Independent Technical Audit of Los Alamos National Laboratory for Compliance with the Clean Air Act, 40 CFR 61, Subpart H in 1999

DOJ File Number: 90-5-1749A

Case Name: *CCNS v DOE*

December 2000

Figure 2. Comparison of CAP-88 χ/Q values and CALPUFF χ/Q values. The black line indicates exact correlation between CALPUFF and CAP-88. CALPUFF χ/Q values exceed those of CAP-88 for the points that lie above the line.

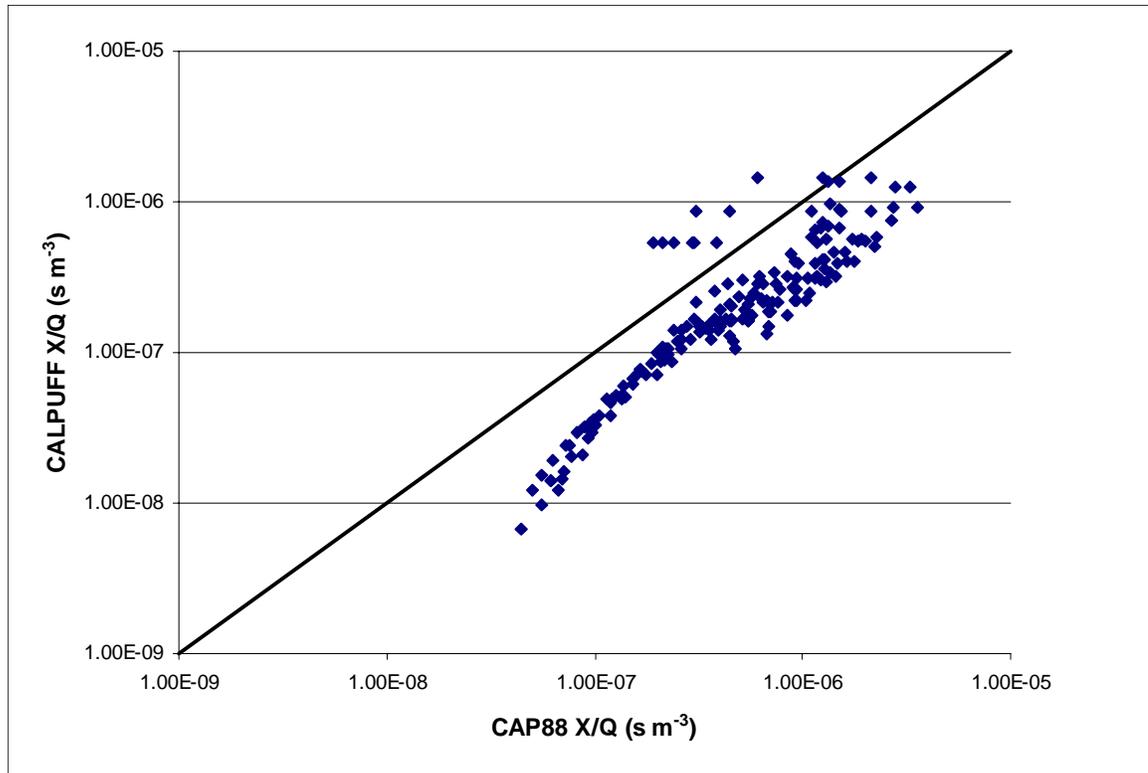
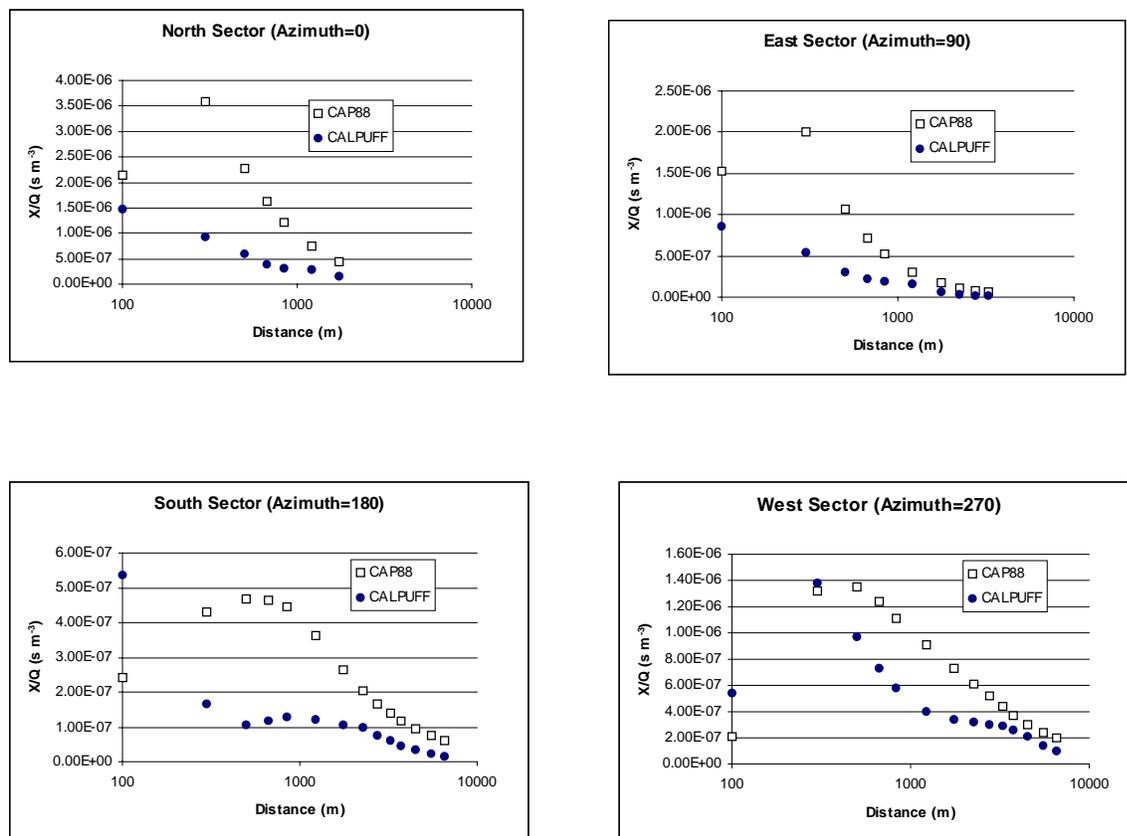
As a means of exploring this issue, the audit team looked at a comparison of the dispersion parameters predicted by CAP-88 and CALPUFF,¹⁰⁹ a complex terrain model that explicitly models spatial variability in terrain and wind vectors. The dispersion parameter (χ/Q) is the ratio of the downwind air concentration to the release rate.

A plot of annual average CALPUFF χ/Q values versus annual average CAP-88 χ/Q values (Figure 2) shows CAP-88 generally has higher χ/Q values compared to those of CALPUFF. Higher χ/Q values indicate less plume spreading and consequently, higher pollutant concentrations. On average, CAP-88 χ/Q values are a factor of 2.75 higher than CALPUFF. Approximately 6% of the CALPUFF χ/Q values were higher than the corresponding CAP-88 χ/Q values. Of these χ/Q values, only 5 values were a factor of 2 or more greater than the corresponding CAP-88 values. Differences in CAP-88 and CALPUFF χ/Q values as a function of distance and azimuth from the source are shown in Figure 3. The CAP-88 results show the effect of plume lofting over the nearest receptor (100 m). The CALPUFF results generally do not show plume lofting effects. However, it is strongly suspected that the CALPUFF modeling grid was too coarse to resolve plume lofting effects close to the sources. Difficulty in resolving close-in receptors may have contributed to some CALPUFF χ/Q values being higher than CAP-88 χ/Q values close to the source. Almost all cases in which CALPUFF χ/Q values exceeded those of CAP-88 were for receptors close to the source (~100 m). A more complete description of the calculations done for this comparison appears as Appendix E to this report.
